September 26, 1995

FYRNETICS INC.

Regarding: New smoke alarm Model 0914

0925-5201 REV.00
MINIATURE S/D

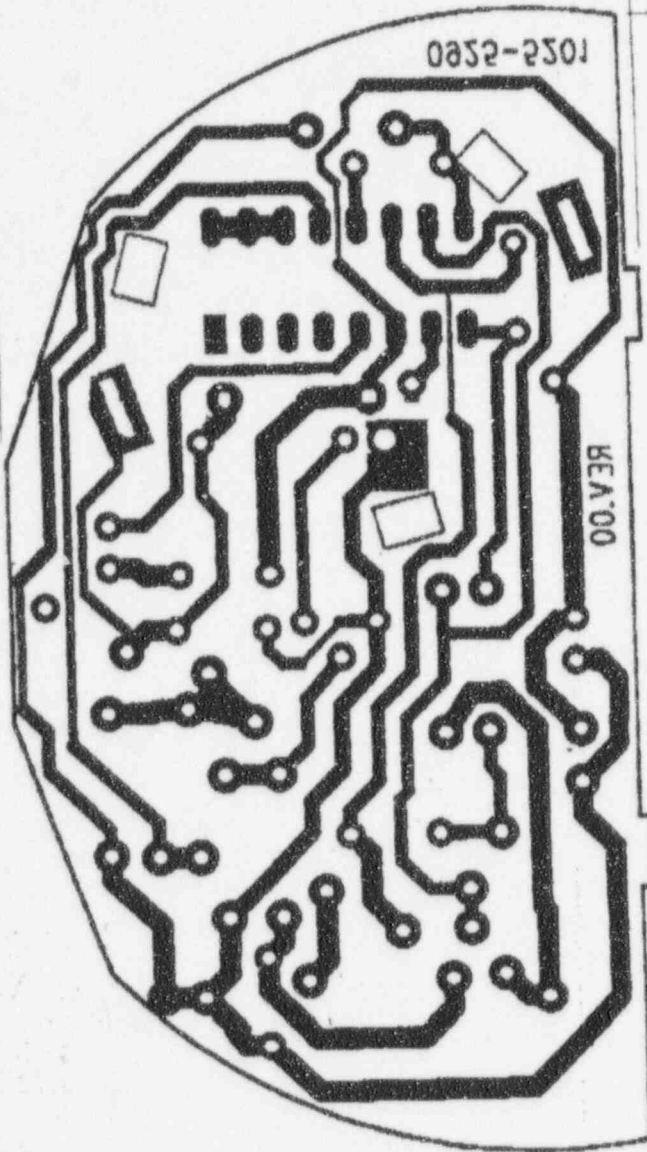
The 0914 will use the same chamber as the 0915. The attachment of the chamber to the printed circuit will be the same as the 0915 (soldered to the PCB). The Printed circuit board will be a smaller version of the 0915 circuit board, it will have the same shape as the 0915 printed circuit board. The circuit board will snap into the plastic base as it does on the 0915. The Piezo horn will be the same as the one used on the 0915.
